Capital School District
Central Middle School
Interior Renovations
211 Delaware Ave. Dover Delaware 19901
Bid Pac E— Contracts 1 thru 10
October 7, 2024

Addendum No. 1

PROJECT: Central Middle to Elementary School Interior Renovation

PROJECT NO: 2021101.00

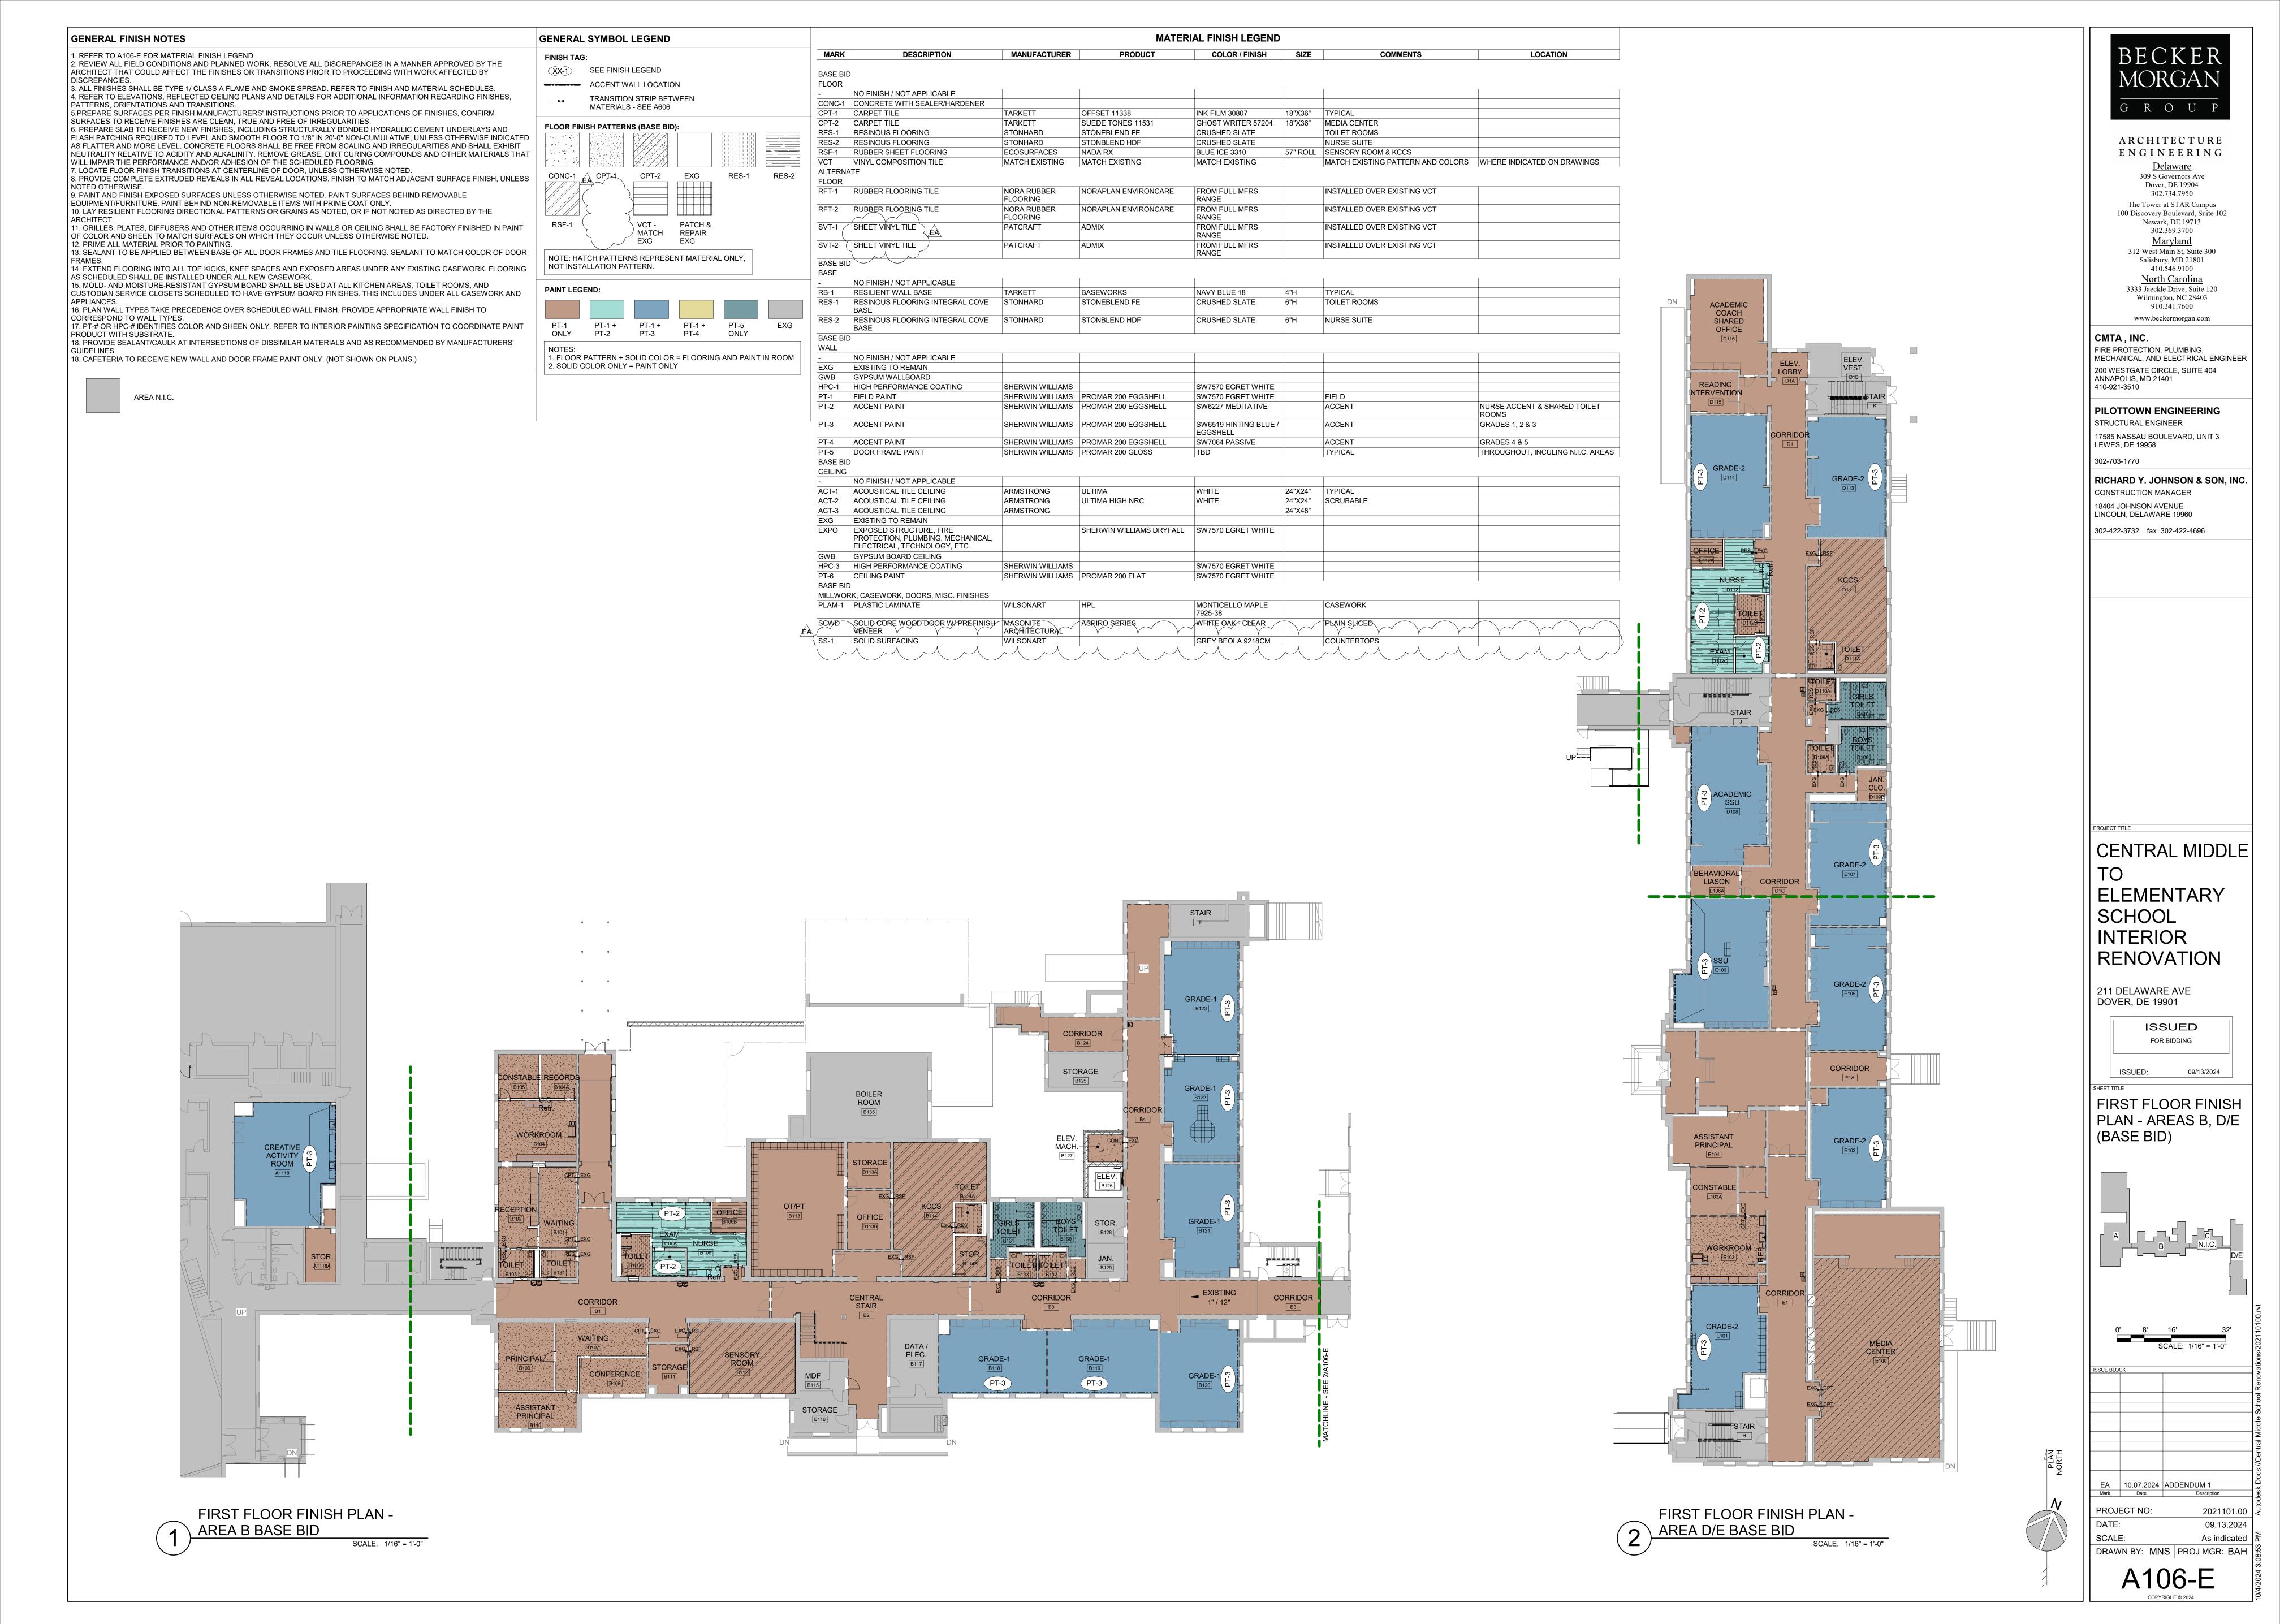
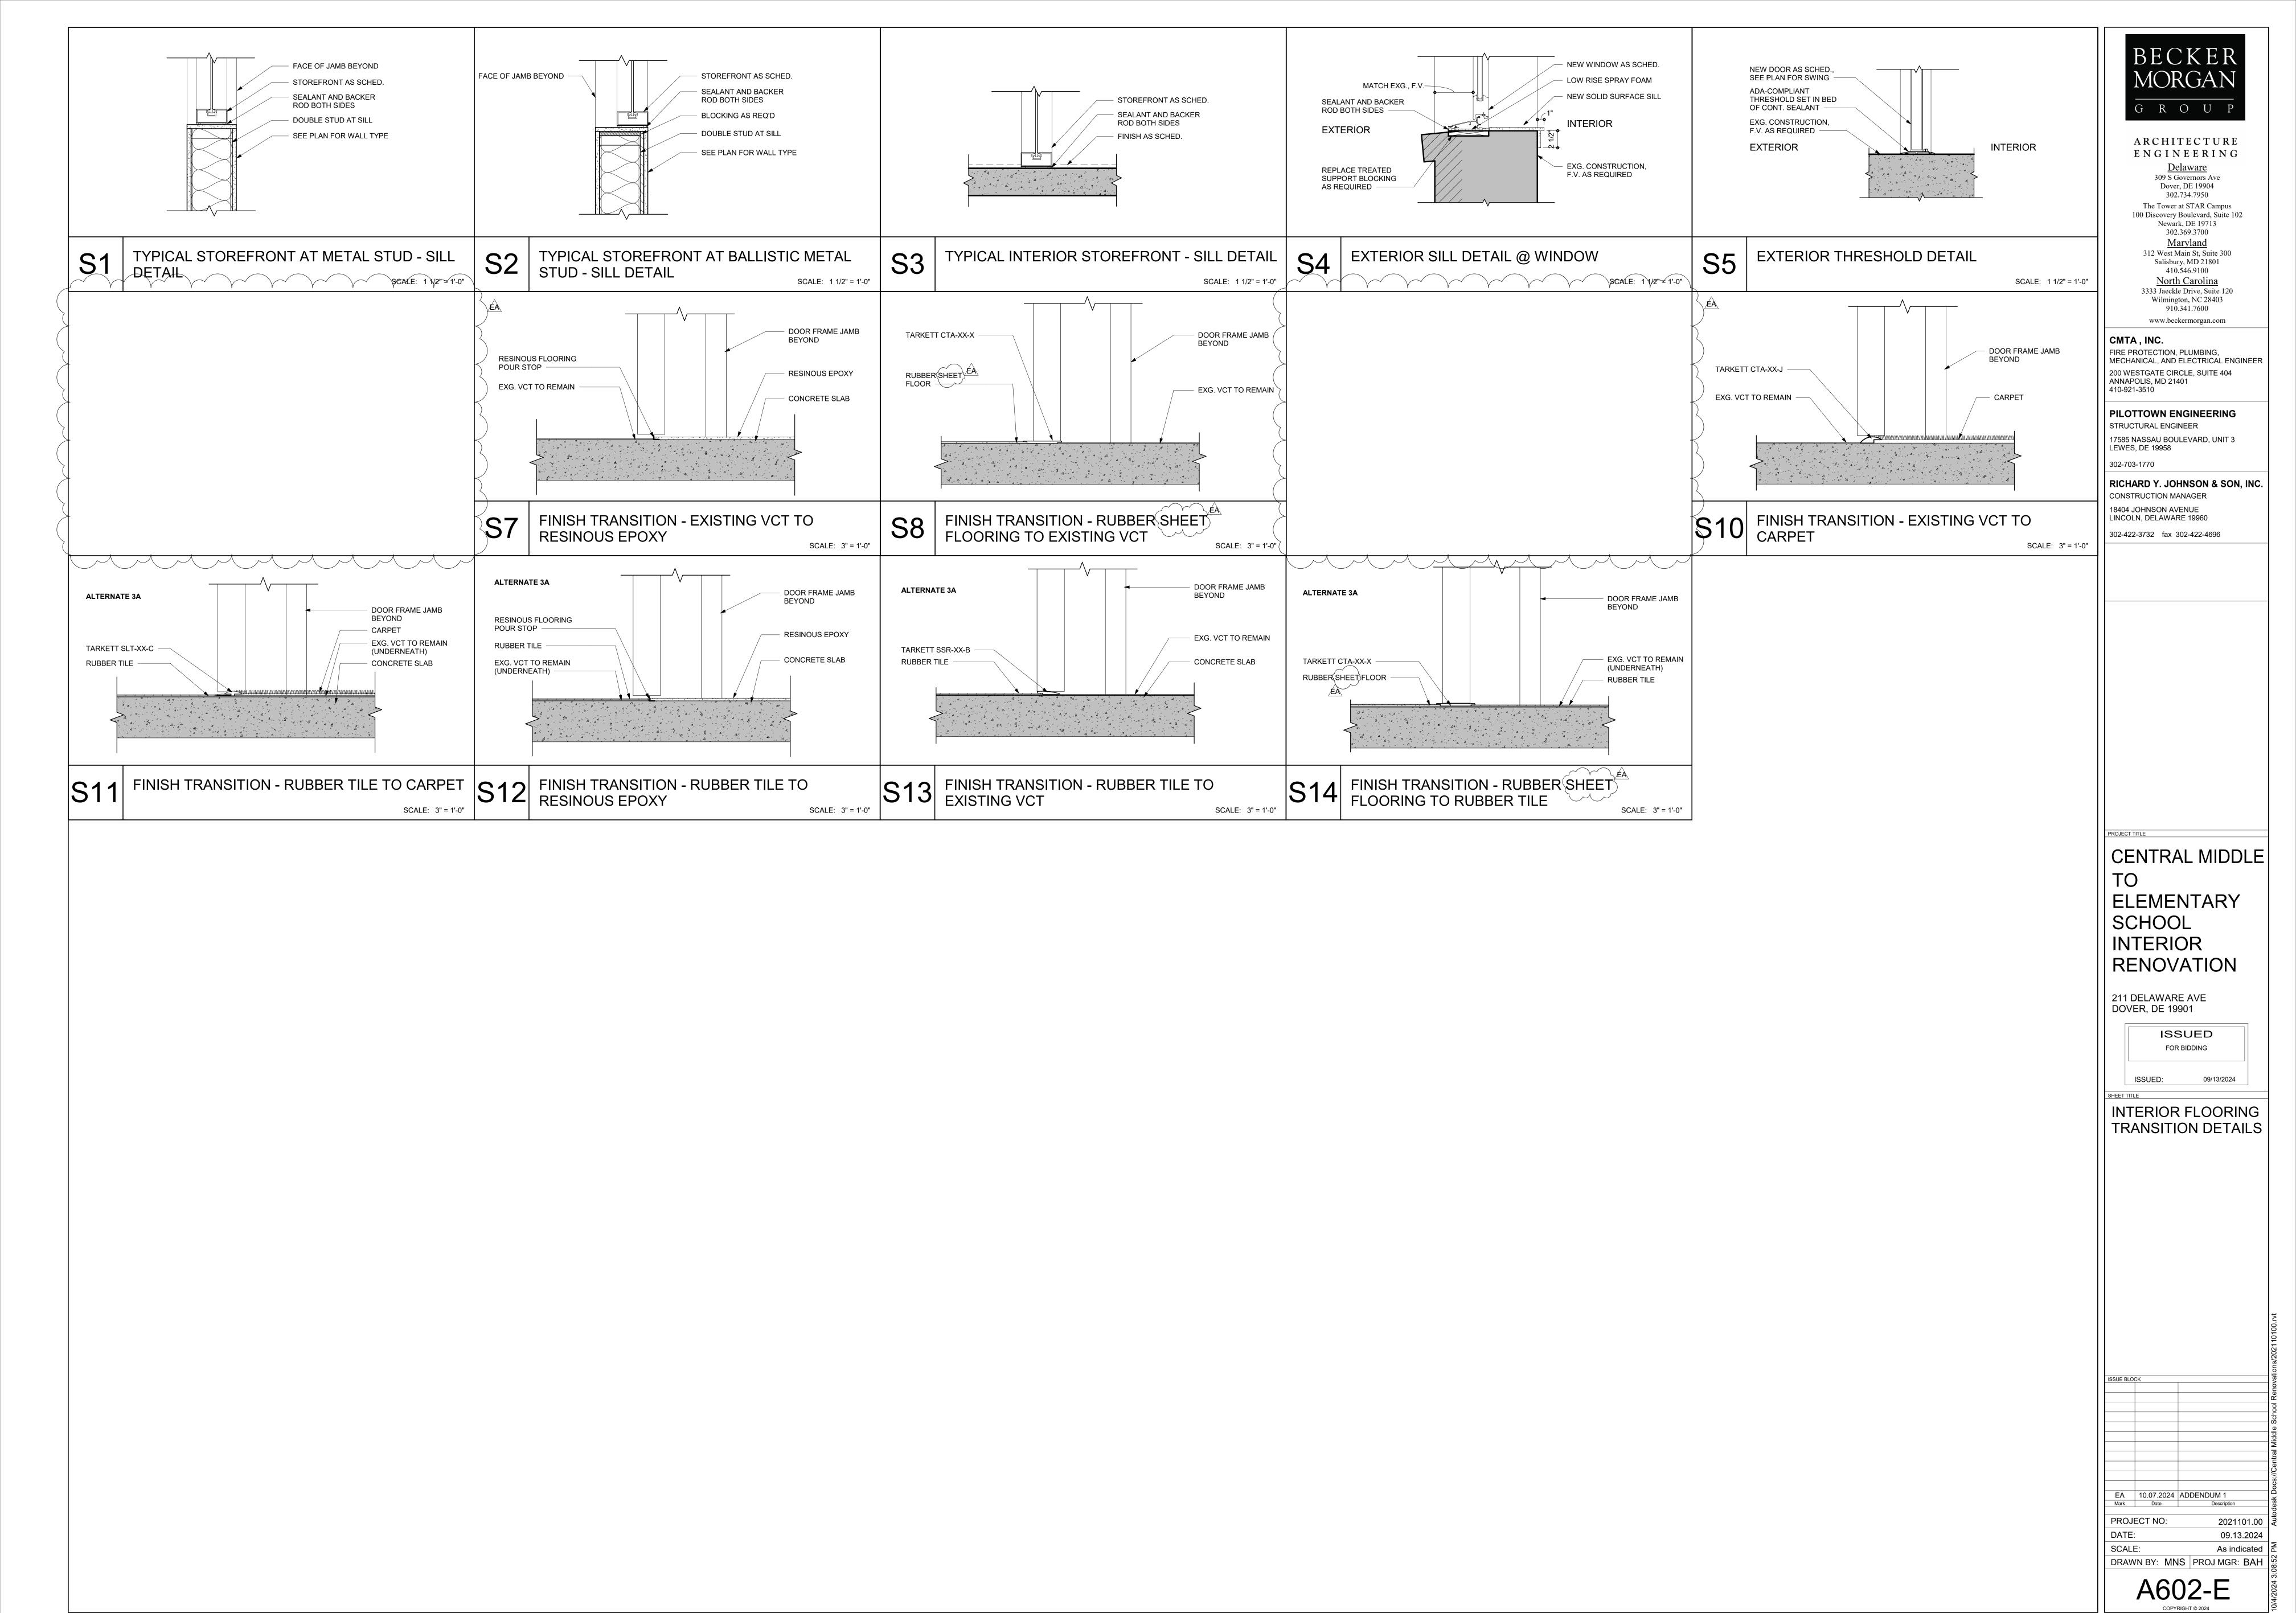
- 2. A101D-E FIRST FLOOR PLAN AREA D/E
 - a. Detail 1:
 - i. **ADD** exam curtains (3) in nurse's suite.
- 3. A106-E FIRST FLOOR FINISH PLAN AREAS B, D/E (BASE BID)
